**TITLE:** **CHANGE OF ZONE NO. 07060, Wilderness Heights Planning Unit Development**, requested by Lincoln Federal Bancorp, on property generally located southeast of the intersection of South 40<sup>th</sup> Street and Yankee Hill Road.

# LINCOLN/LANCASTER COUNTY PLANNING STAFF REPORT

- PROJECT #:** Annexation #07003  
**Change of Zone #07060 PUD**
- PROPOSAL:** From AG to R-3 and B-2 PUD for 225,000 square feet of commercial floor area and 66 dwelling units.

**WILDERNESS HEIGHTS**  
**P.U.D. LEGAL DESCRIPTION**  
**LINCOLN, NEBRASKA**

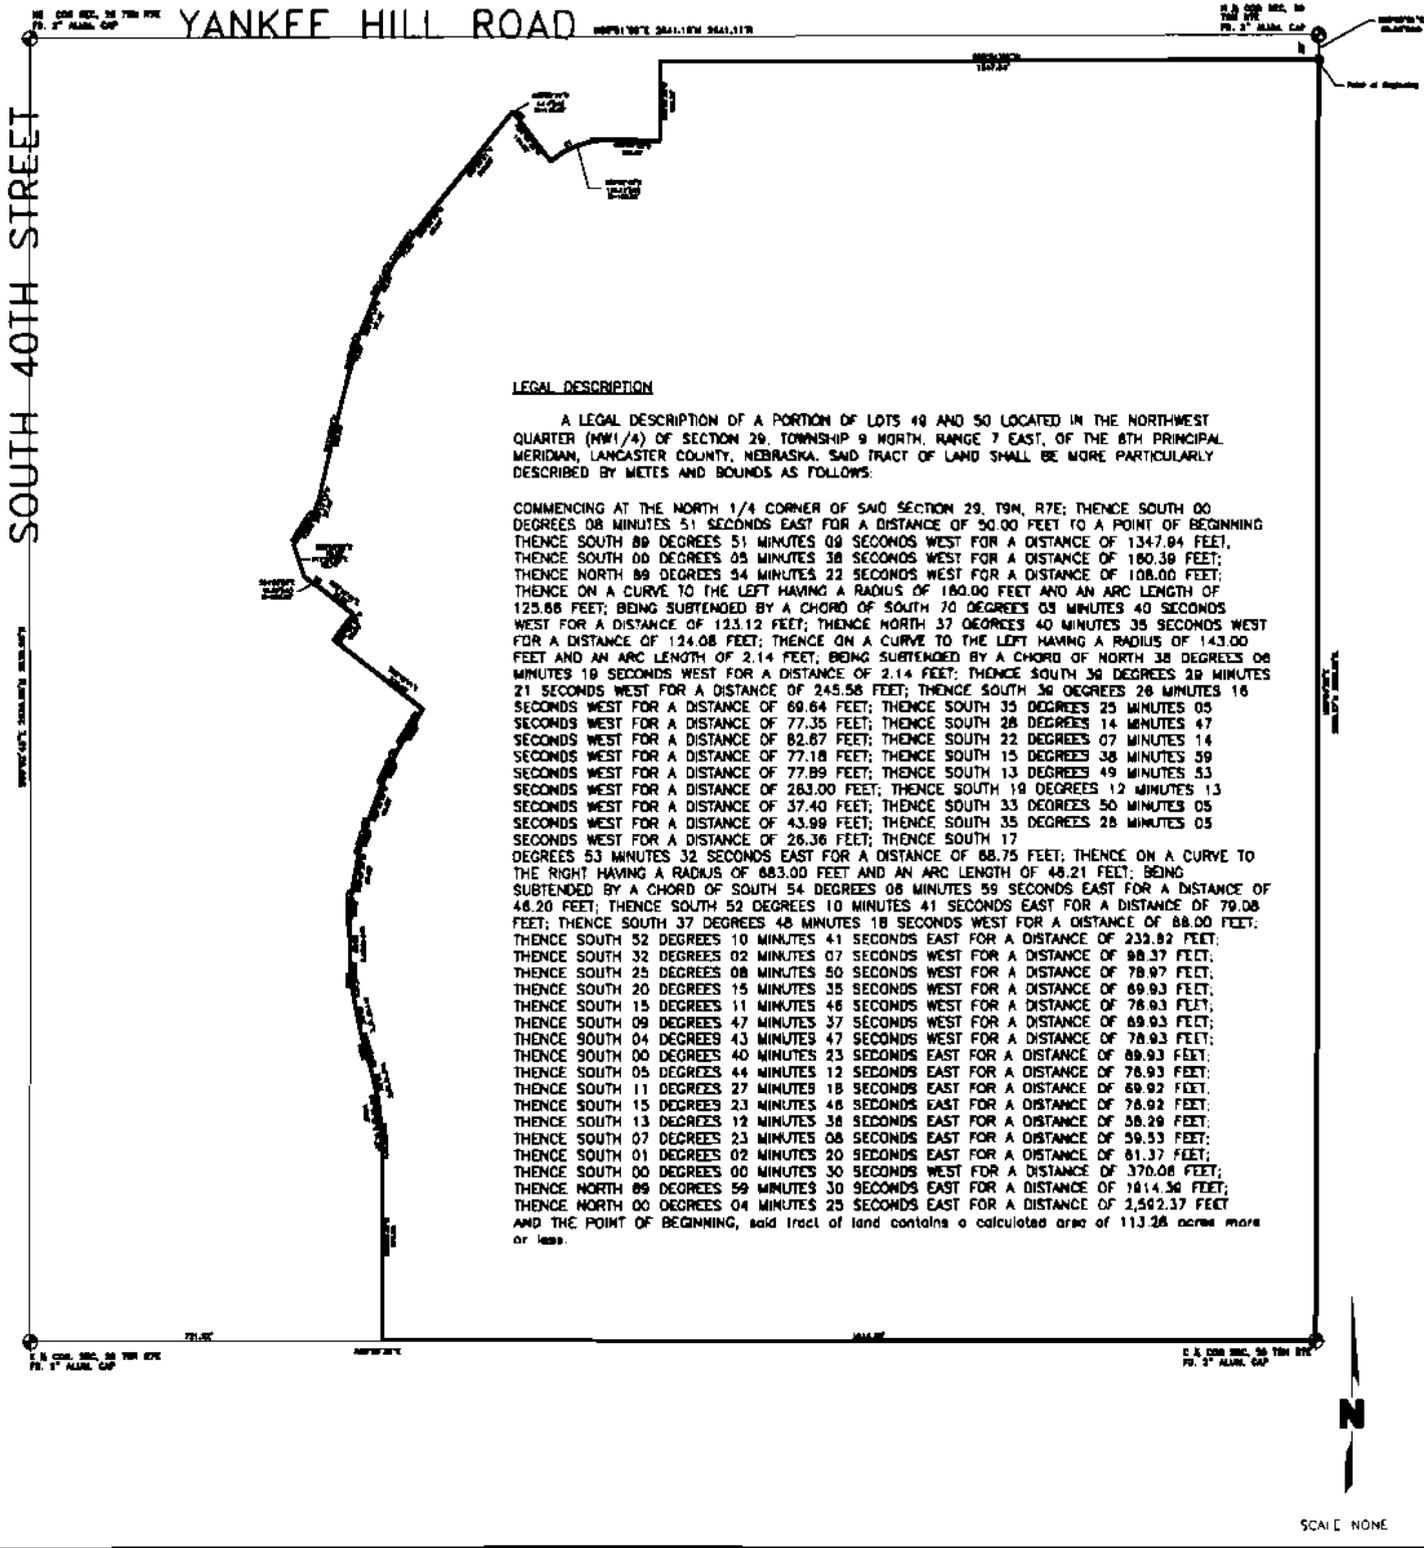
- 1.1 Revise the site plan to show the following:
- 1.1.1 Show utility easements per the L.E.S. review.
  - 1.1.2 Change NORTHEAST to NORTHWEST in the second paragraph of the legal description on Sheet 1 of 5.
